1 *Insert new clause 44 as shown:*
2
3

4 **44. Equal Cost Multiple Paths**
5

Figure 44-1—SPBM MEP and ECMP path MEP placement in a CBP

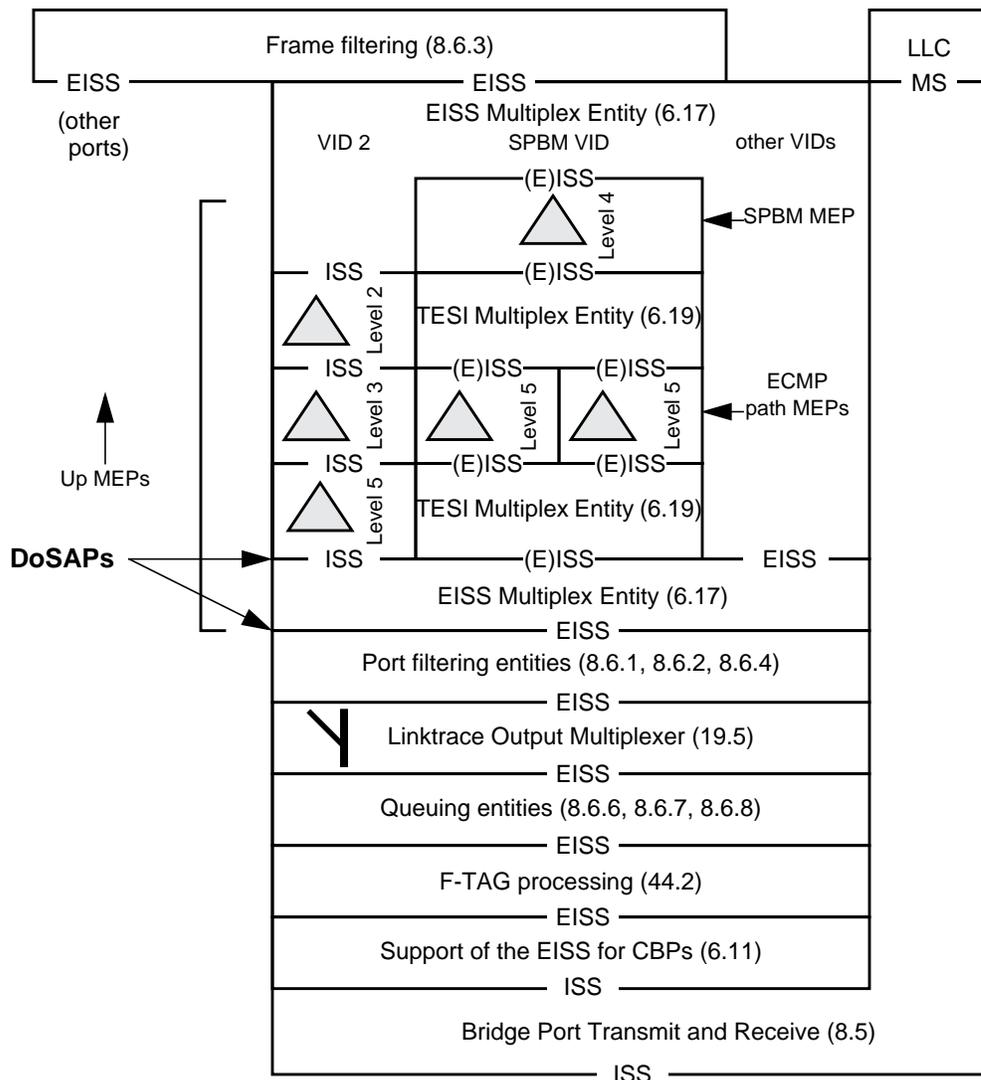
Since ECMP path MEPs must only see traffic from one other endpoint, these MEPs need to be further differentiated by the TESI Multiplex Entity (6.19). This locates an ECMP path MEP so that it receives

CCMs only from the other MEP in its MA. Figure 44-1 also shows an example of ECMP path MEPs on a CBP.
